Well Name: SAKER 6-7 FEDERAL COM	Well Location: T24S / R35E / SEC 6 / LOT 1 / 32.253325 / -103.399826	County or Parish/State: LEA / NM
Well Number: 6H	Type of Well: OIL WELL	Allottee or Tribe Name:
Lease Number: NMNM014164	Unit or CA Name:	Unit or CA Number:
US Well Number: 3002549458	Operator: OXY USA INCORPORATED

Type of Submission: Notice of Intent

Type of Action: APD Change

Procedure Description: Oxy USA Inc., respectfully requests approval to amend the subject well AAPD to change the SHL, BHL, Pad and amend the casing to our 3-string slim design. See attached APD sundry change overview worksheet along with the updated well plat and drilling documents. The surface hole is moving to an existing pad. "The SHL is moving 140' to the east and there is no additional surface disturbance related to this sundry"

Form C-102
Revised August 1, 2011
Submit one copy to appropriate
District Office

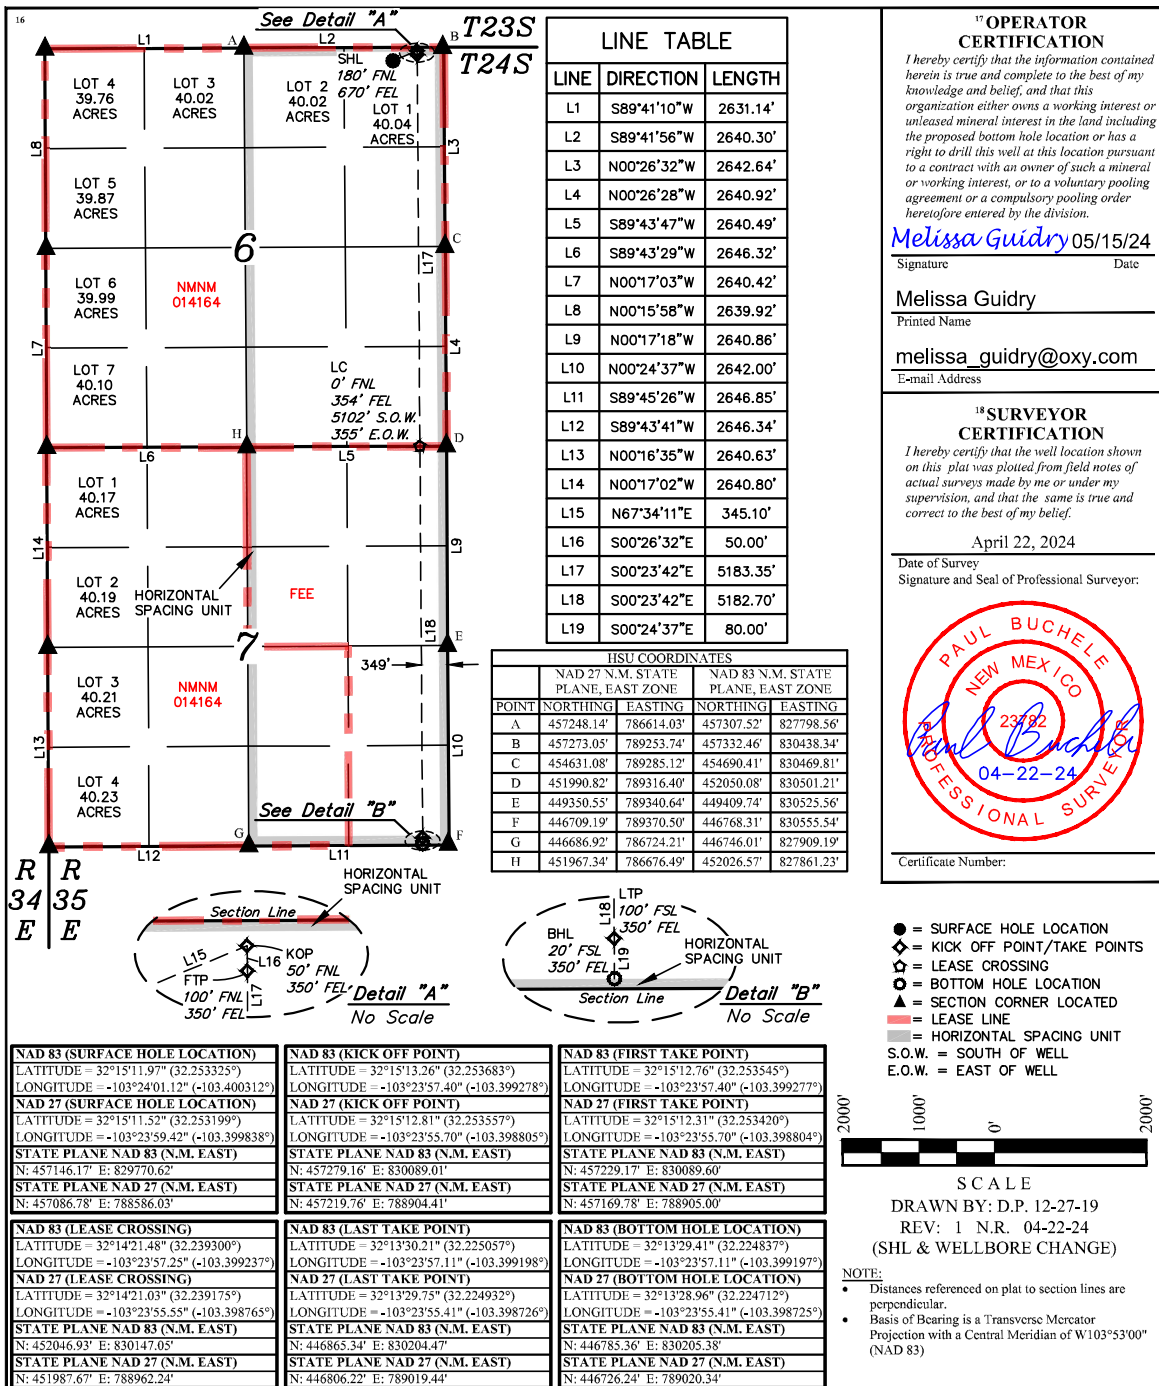
ITEM	PREVIOUS PLAN	UPDATED PLAN
Surface Planning	NAME	SAKER 6_7 FEDERAL COM 4H	N/A
	NSL	N/A	N/A
	SHL	180 FNL 520 FEL	180 FNL 670 FEL
	PAD	Falcon Ridge 0605 PAD	Falcon_T24SR35E_6_Pad 3
	BHL	20 FSL 331 FEL	20 FSL 350 FEL
	HSU SIZE, ACRES	640.06	N/A
	POOL	Bone Spring	N/A
	TARGET FORMATION	Avalon	THIRD BONE STRING LIMESTONE
Drilling	TVD	19300'	21477'
	SURFACE CASING	17.5 in, 13.375 in, 54.5 lbs, J-55 BTC	14.75 in, 10.75 in, 45.5 lbs, J-55 BTC
	INTERMEDIATE CASING	12.25 in, 9.625 in, 40 lbs, L-80 BTC	9.875 in, 7.625 in, 26.4 lbs, L-80 HC BTC
	INTERMEDIATE 2 CASING	NA	9.875 in, 7.625 in, 29.7 lbs, L-80 HC BTC
	PRODUCTION CASING	8.5 in, 5.5 in, 20 lbs, P-110 DQX	6.75 in, 5.5 in, 20 lbs, P-110 Sprint-SF
	LINER OR TIE BACK	NA	N/A
	CEMENT - SURFACE (TAIL)	884 sxs, 14.8 lb, 1.33 yld, Class C + Accel	702 sxs, 14.8 lb, 1.33 yld, Class C + Accel
	CEMENT - INTERM (TAIL)	155 sxs, 14.8 lb, 1.33 yld, Class C + Accel	357 sxs, 13.2 lb, 1.68 yld, Class C + Ret., Disper

The C-102, DRILL PLAN, CASING CONNECTIONS AND DIRECTIONAL PLAN ARE ATTACHED. UPDATED VARIANCE REQUESTS FOR BOP BREAK TESTING, BRADENHEAD CBL, AND OFFLINE CEMENT ARE ATTACHED. "THE SHL IS MOVING 150' TO THE EAST AND THERE IS NO ADDITIONAL SURFACE DISTURBANCE RELATED TO THIS SUNDRY"
